**NO FURTHER ACTION DECISION DOCUMENT FOR
SS-029, JET ENGINE TEST CELL
PLATTSBURGH AFB, NY
DECLARATION STATEMENT
SEPTEMBER 2000**

SS-029, Jet Engine Test Cell
Plattsburgh AFB, NY

Re: Review of the Draft Site Investigation Report for the Jet
Engine Test Cell (Site SS-029)

EPA COMMENTS ON THE DRAFT SITE INVESTIGATION REPORT FOR THE JET
ENGINE TEST CELL (SITE SS-029)

FIGURE 1-3

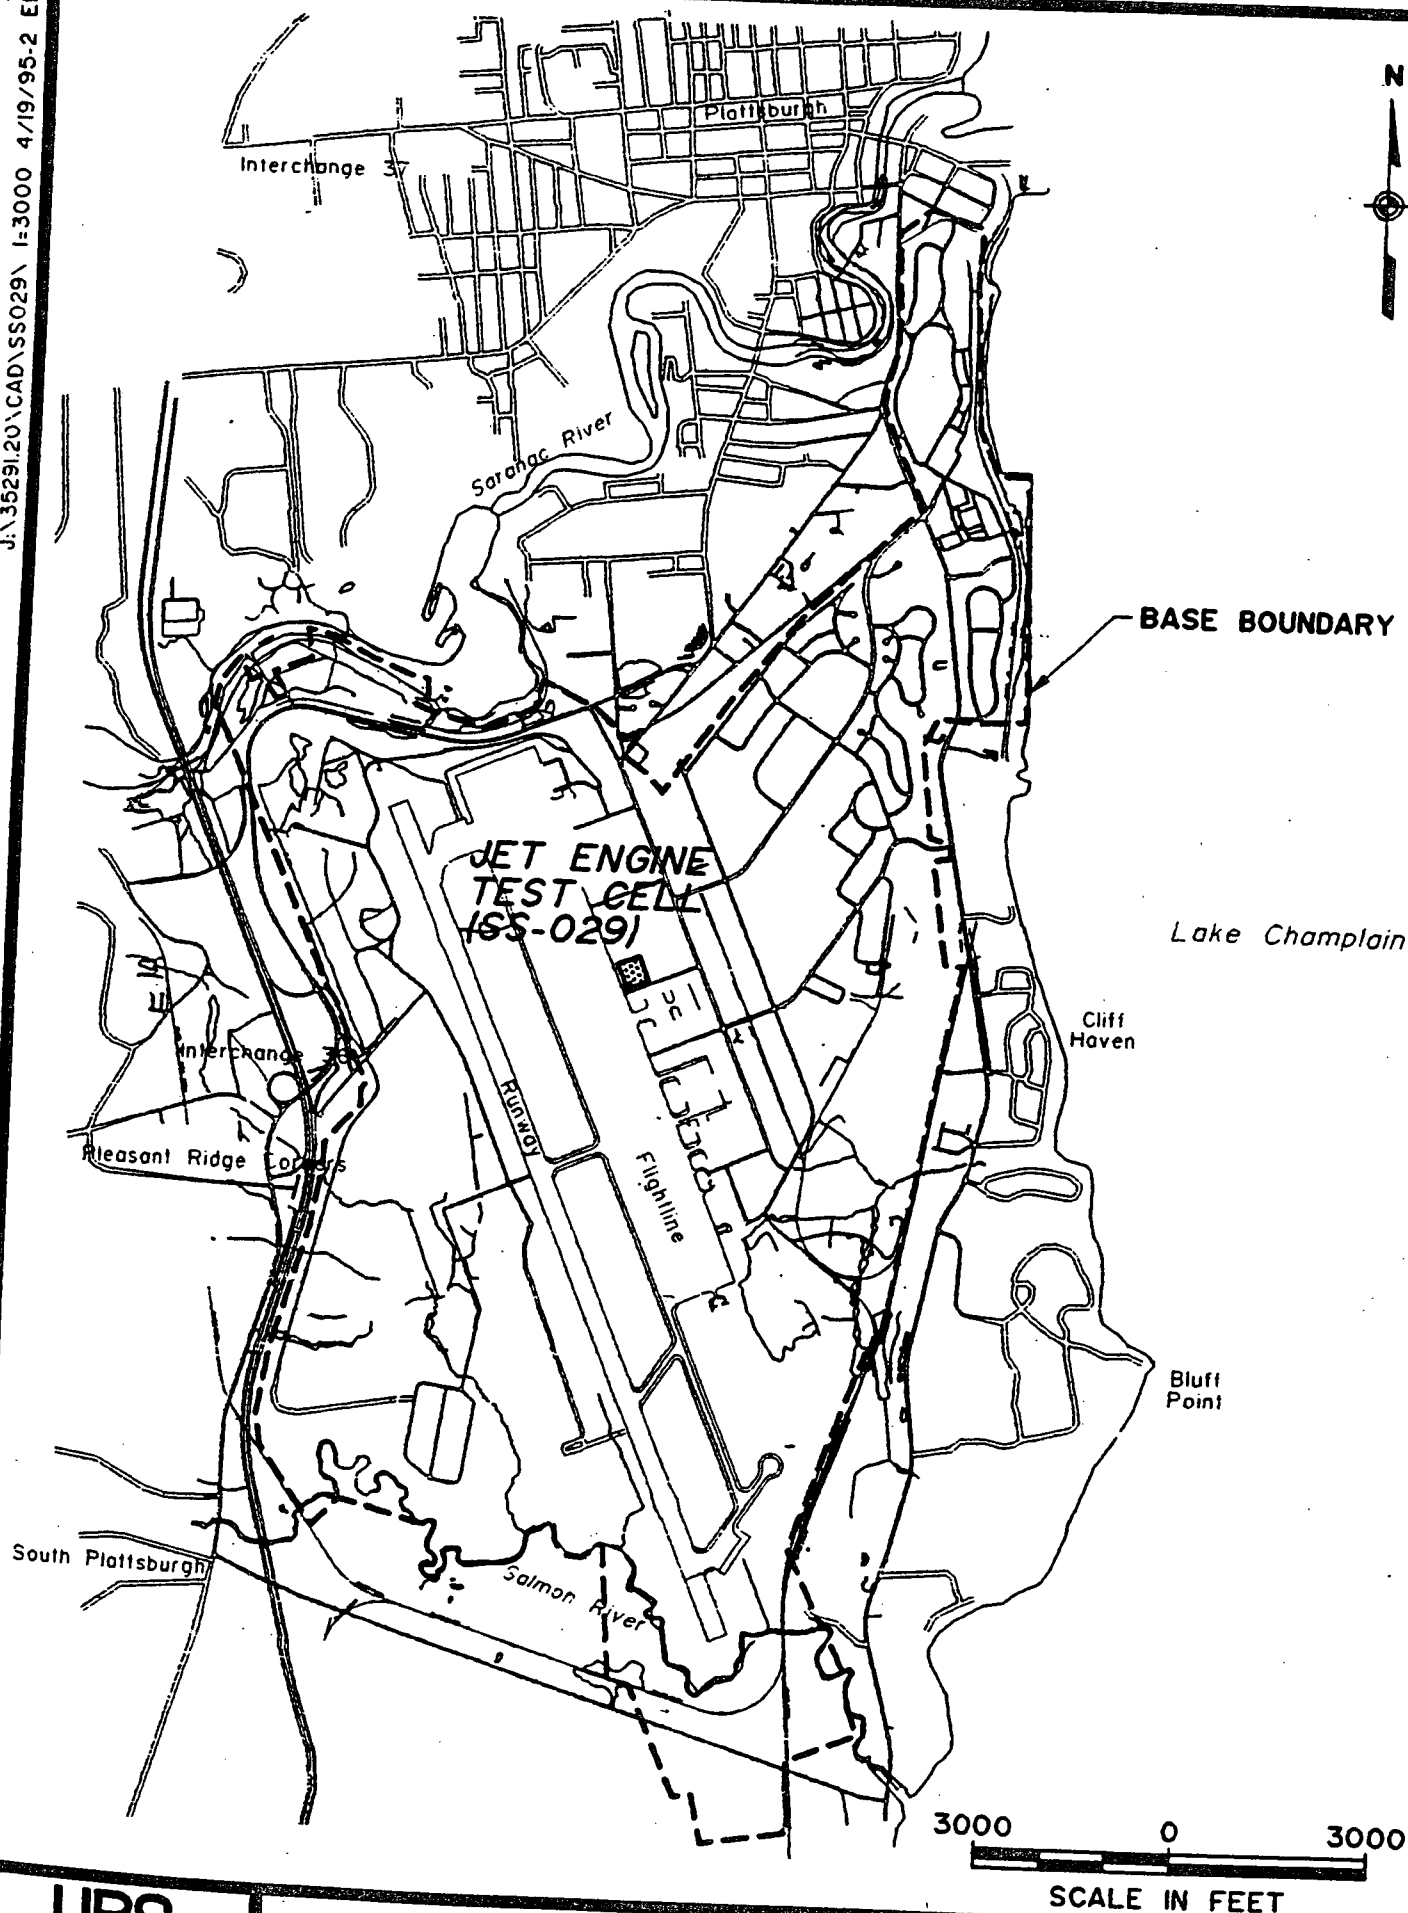
Page 1-1, Section 1.2, Paragraph 2: Is the waste oil tank which receives the discharge from the oil/water separator located in the same partially-buried housing as the oil/water separator? If not, please locate the oil tank on Figure 1-3, and indicate whether it is an underground storage tank (UST) or an aboveground storage tank (AST).

Page 1-1, Section 1.2, Paragraph 3: Was the previous oil/water separator, installed in 1971, located in the same place as the current oil/water separator? If not, please locate the former oil/water separator on Figure 1-3. A soil sample should be collected from the location of the former oil/water separator if it was in a location not in proximity to the location of the current oil/water separator.

Page 1-4, Figure 1-3: The boundaries of site SS-029 should be marked on the figure. Based on the figure and additional information presented in Section 1, it is not clear where the limits of the site lie.

Page 1-4, Figure 1-3: Several miscellaneous artifacts (i.e., 36"

and 12" manholes north of tank 2820-1, 4' cap in concrete adjacent to the southeast corner of Building 2820, etc) are depicted on the figure. Has the history and physical features of such artifacts been investigated in order to determine whether they could indicate the presence of potential source areas?

Page 1-9, Table 1-1: The table states that tank UST-2820-2 was located north of Building 2820, across the road. Figure 1-3 indicates that this tank was located on the same side of the road as Building 2820. Please resolve this discrepancy.
